ADDENDUM NO. 2 TO TUCSON AIRPORT AUTHORITY TUCSON INTERNATIONAL AIRPORT

10119102 AIRFIELD SAFETY ENHANCEMENT (ASE) PROGRAM DESIGN BID BUILD 2 SERVICES

April 1, 2026

SHEET REFERENCE NUMBER:
EP1.001
 SHEET 30 OF 36

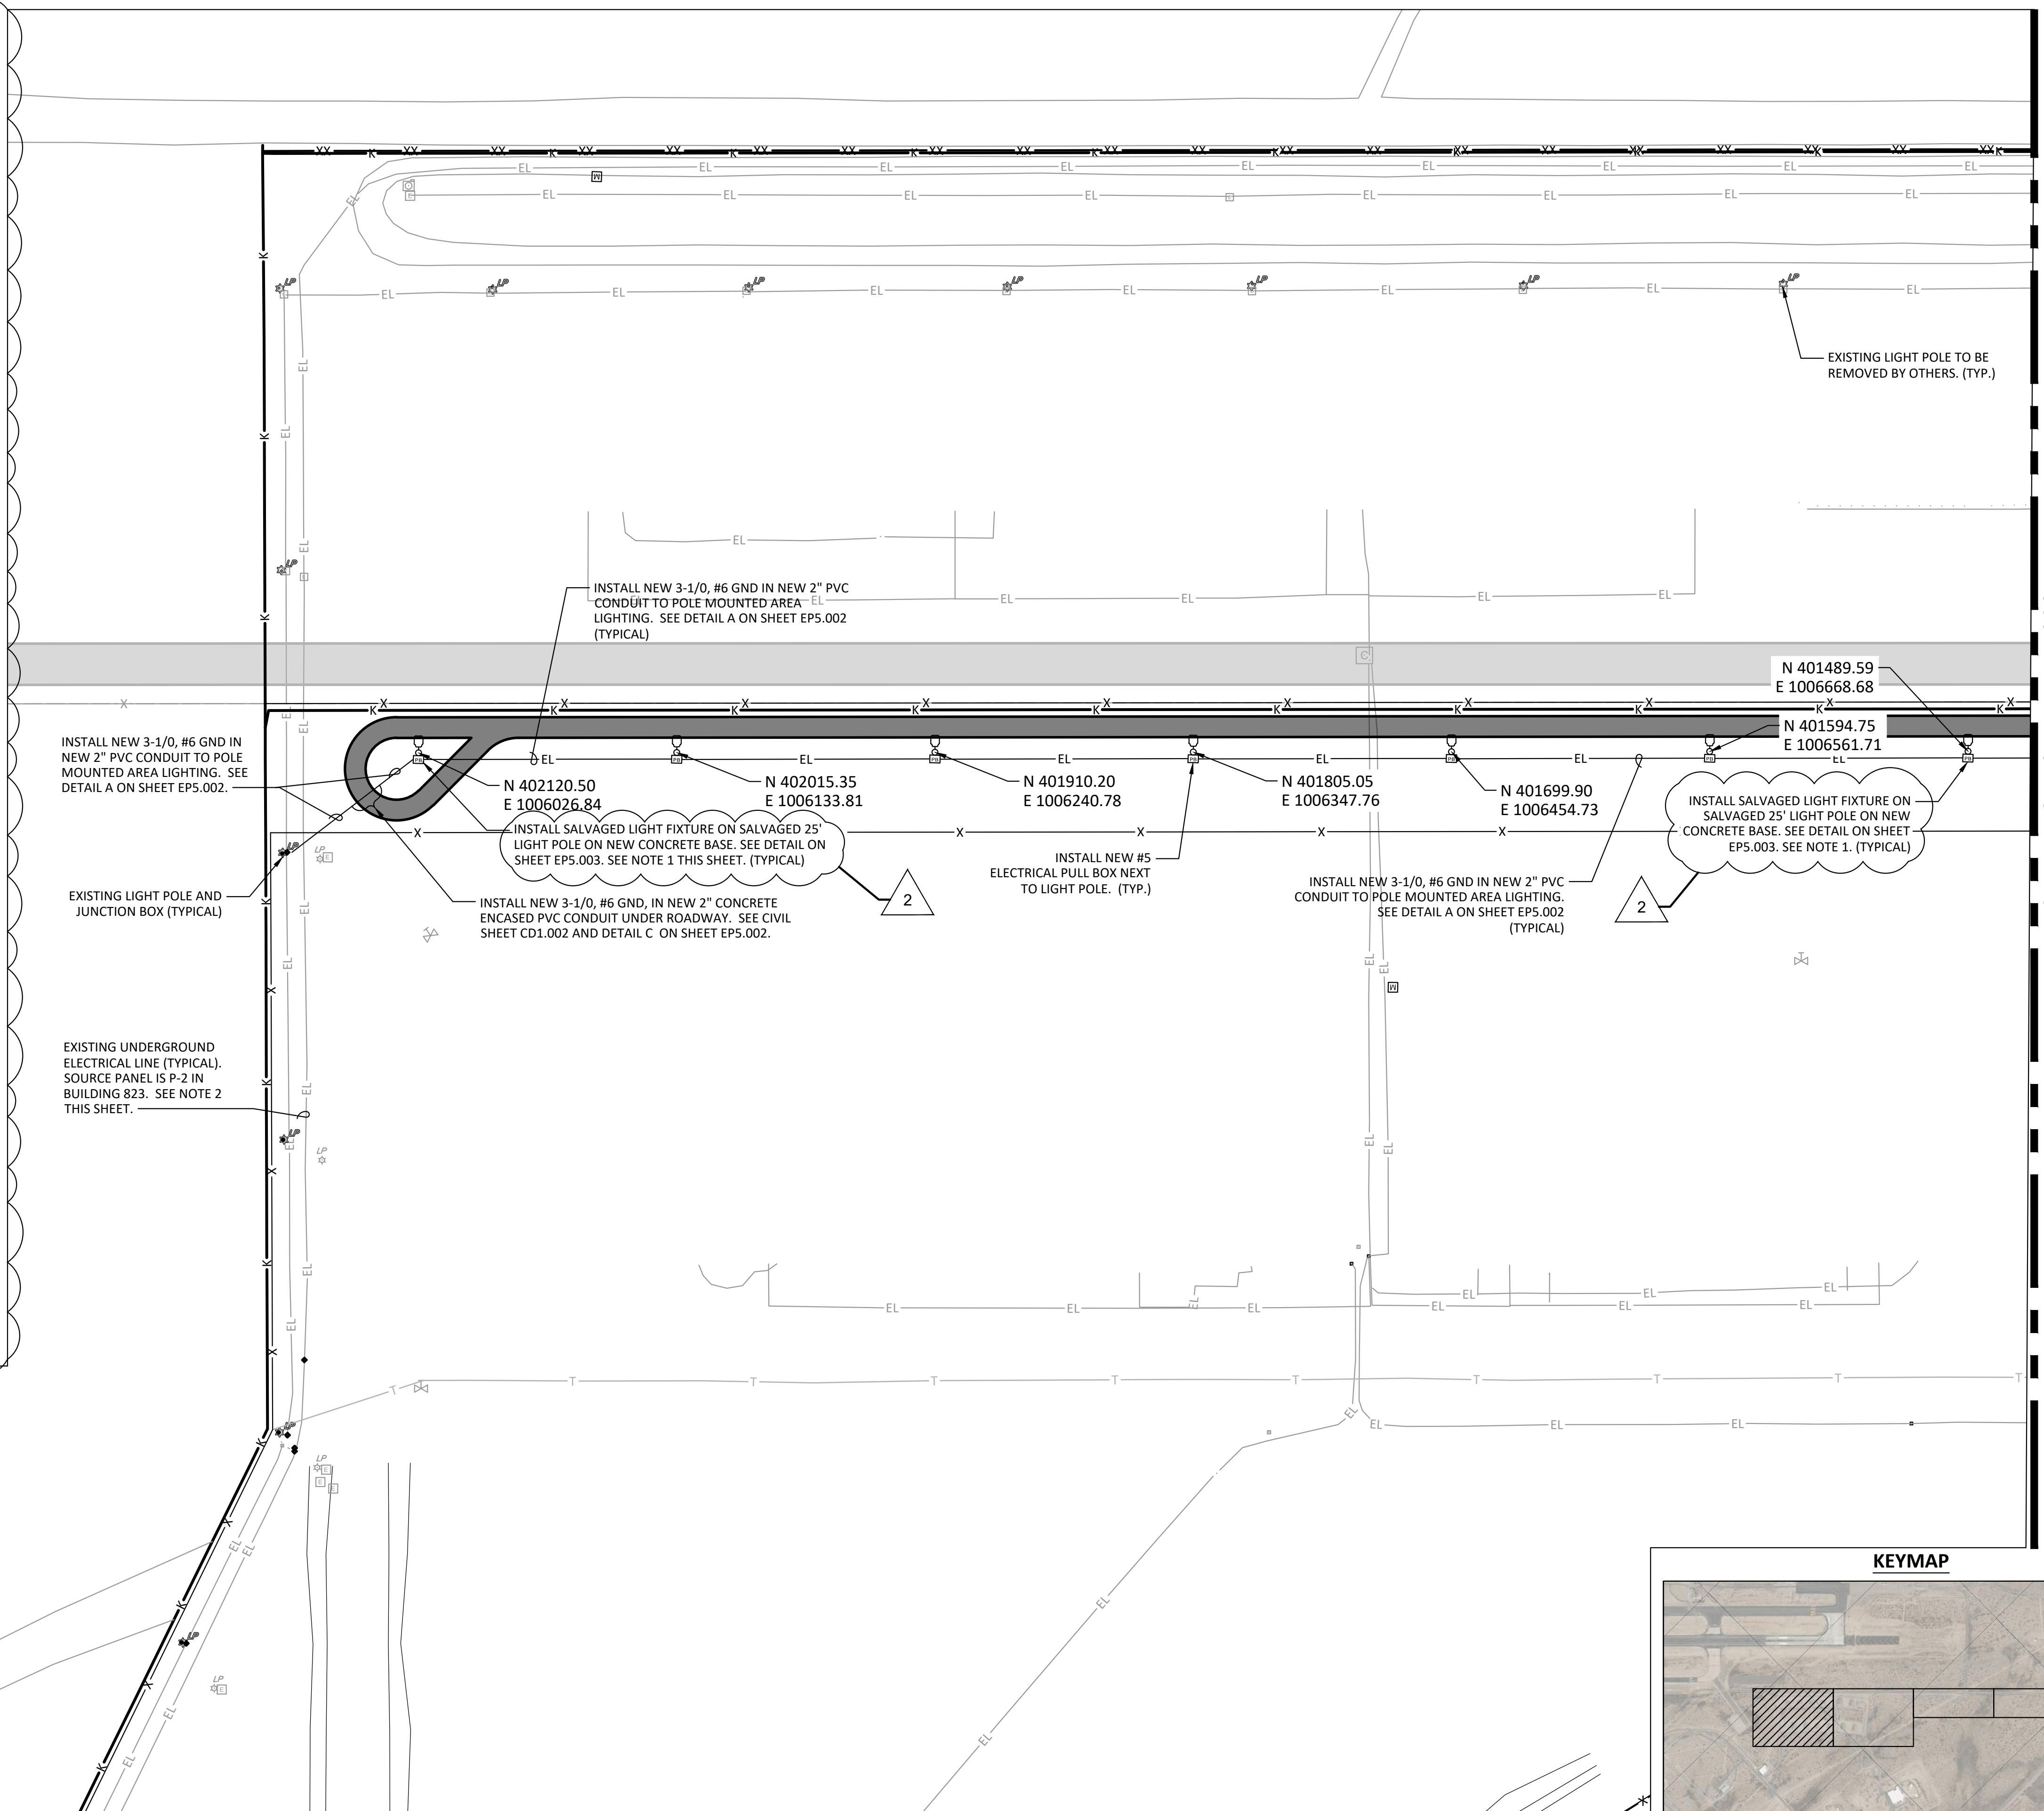
1. Sheet GI0.002 Index of Sheets & Summary of Quantities – Updated Summary of Quantities
2. Sheet EP1.001 Electrical Installation Plan I – Updated light pole callouts
3. Sheet EP1.002 Electrical Installation Plan II – Updated light and camera pole callouts
4. Sheet EP1.003 Electrical Installation Plan III – Updated camera pole callouts
5. Sheet EP1.003 Electrical Installation Plan III – Updated camera pole callouts
6. Sheet EP5.001 Camera Pole Base Detail – Updated Note 9
7. Sheet EP5.003 Lighting Pole Base Details – Updated pole height dimensions

Question 7: Note 1 on EP1/003 indicates that: "SECURITY CAMERA POWER ORIGINATES FROM AN EXISTING 225A, 480V, 3 PH, 3W PANELBOARD LOCATED BETWEEN EXISTING SECURITY CAMERAS POLE 13 AND 14 ALONG TAA PROPERTY LINE." If we are going to run this new power feeder can we get this location defined on the electrical print set?

Question 8: What is the electrician's responsibility regarding this note from sheet EP1.002: "APPROXIMATE LOCATION OF RELOCATED ZONE SECURITY PANEL. FINAL LOCATION AND SOURCE PANEL TO BE DETERMIND." Is this the source panel for the new security cameras?

Answer: See note 2 on revised sheet EP1.001

Answer: See note 2 on revised sheet EP1.001. The power panel is located in Existing Building 823.

1. SALVAGED LIGHT FIXTURES ARE RATED AT 480V, 1PH, 2 WIRE. LIGHTING CIRCUIT ORIGINATES FROM PANEL "P-2" IN BUILDING 823.
2. THE EXISTING IFA MAGAZINE "A" PERIMETER SECURITY FENCE AND ASSOCIATE POLE MOUNTED LED AREA LIGHTING IS SERVED FROM THE EXISTING BUILDING 823 (BLDG. 823 IS A VERY SMALL UTILITY/STORAGE BUILDING LOCATED JUST SOUTH OF BUILDING 870), AND PANEL "P-2" RATED AT 480V, 3 PHASE, 4 WIRE, 225A RATED BUS, 30 CIRCUIT PANEL LOCATED WITHIN BLDG. 823. THE SECURITY FENCE AREA POLE LIGHTING IS SERVED FROM AN UNDERGROUND 480V, 3 PHASE, 3 WIRE BRANCH CIRCUIT ROUTED ALONG THE ENTIRE FENCE INTERIOR PERIMETER. EACH FENCE POLE AND LED FIXTURE IS SERVED BY A DEDICATED UNDERGROUND (UG) PULL BOX AND TAPS THE 3 PHASE BRANCH CIRCUIT ACROSS PHASE-TO-PHASE AT 480V, SINGLE PHASE, 2 WIRE PLUS EQUIPMENT GROUND CONDUCTOR. EACH POLE HAS AN EXTERNAL NEMA 3R JUNCTION BOX MOUNTED AT 18 INCHES ABOVE FINISHED GRADE (AFG) AT THE BASE OF POLE WITH 480V, SINGLE PHASE SPLICE USING TWO (2) IN-LINE FUSES TO SERVE THE POLE MOUNTED AREA LED FIXTURE. THE UNDERGROUND 480V, 3 PHASE, 3 WIRE BRANCH CIRCUIT CONDUCTORS ARE ASSUMED TO BE 3-#1/0 AWG, #6 GND. TAP CONDUCTOR SIZE AT EACH POLE FROM PULL BOX TO JUNCTION BOX ARE 2-#8 AWG, #10 GND, 1" C. THE LED POLE MOUNTED FIXTURE TO BE SALVAGED AND REINSTALLED ON THE NEW POLES HAVE A TYPE V (LIGHT DISTRIBUTION PATTERN, AND ARE RATED AT 480V, SINGLE PHASE, 2 WIRE.
